Historic Architectural Review Commission Staff Report for Item 2

Application Number: H2023-0050

Address: 1208 Virginia Street

~~New~~ Reconstruction of a single-family residence.

1 FRONT ELEVATION
A2.0 SCALE: 1/4"=1'-0"

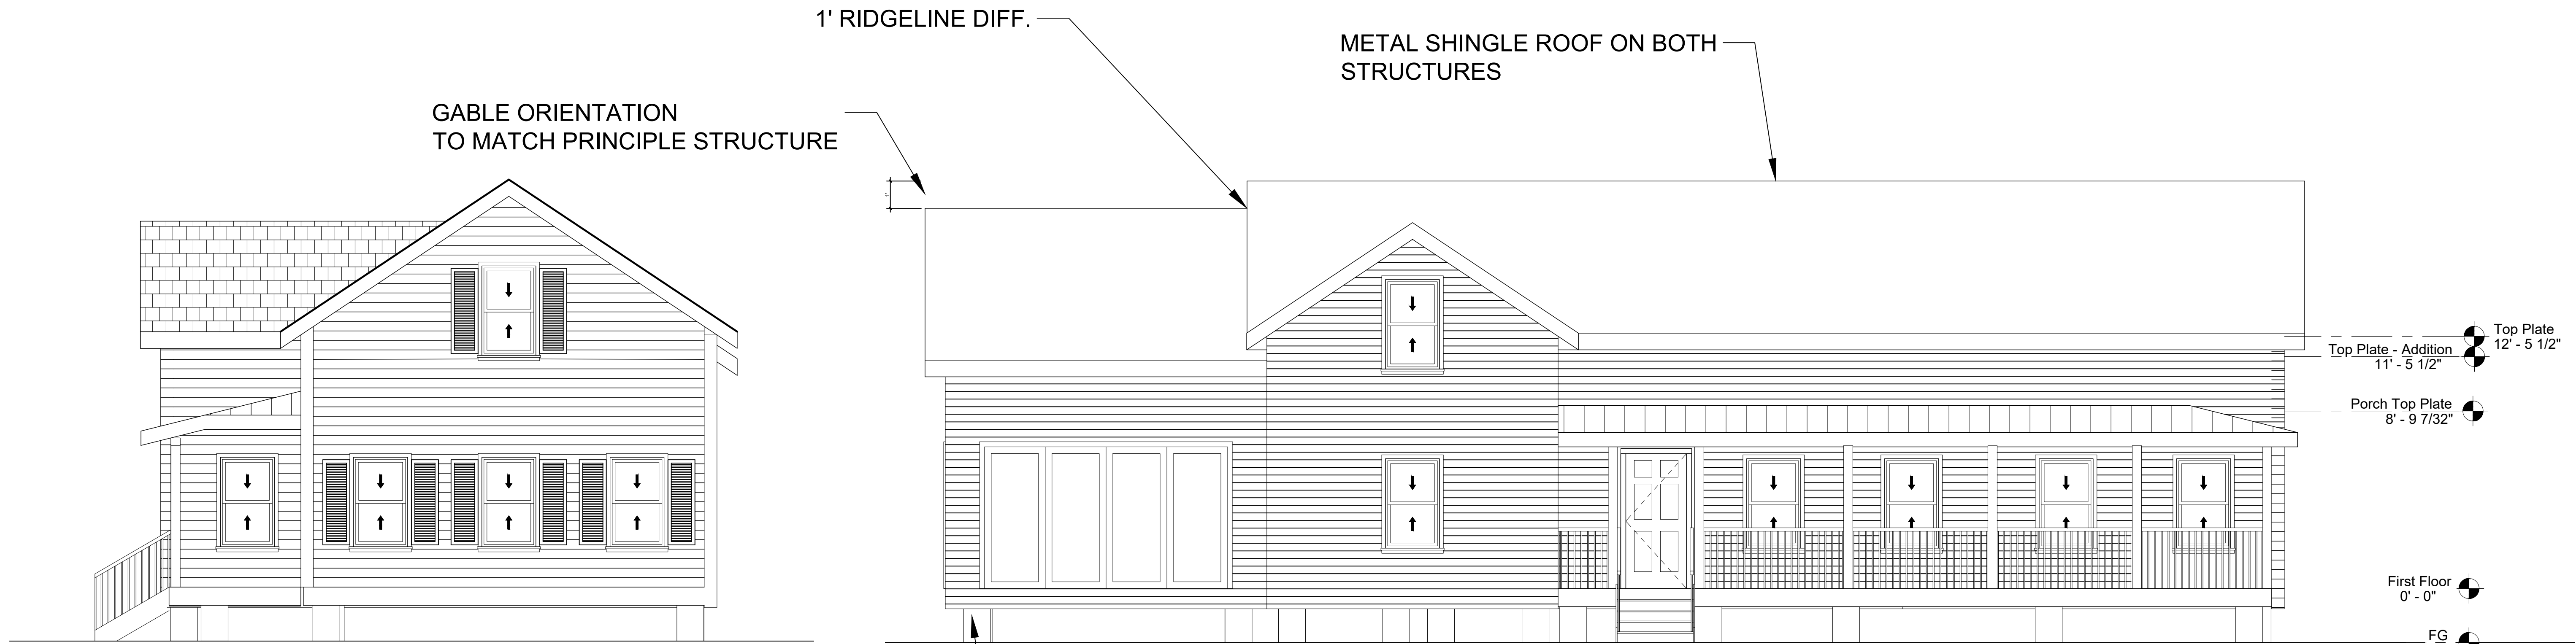
The Certificate of Appropriateness under review proposes the reconstruction of a house on its three-dimensional footprint on a vacant lot where a one and a half-story contributing house used to stand. Maximum height of the house will be approximately 22'- 9 9/16" from grade. The building will keep the same roof and building forms as the historic house used to have. The plans still include the rear addition approved by the Commission during November 29, 2022.

The new structure will be supported with concrete piers of the same height as the previous house. Exterior walls will be finished with horizontal hardie board, windows will be all aluminum impact with 6 over 6 exterior grids and gable roof will be finished with metal shingles. Proposed exterior doors will be aluminum impact.

It is staff’s opinion that the new design proposes the same three-dimensional envelope as the historic and contributing house that used to be on the site, which was appropriate to the streetscape and site.
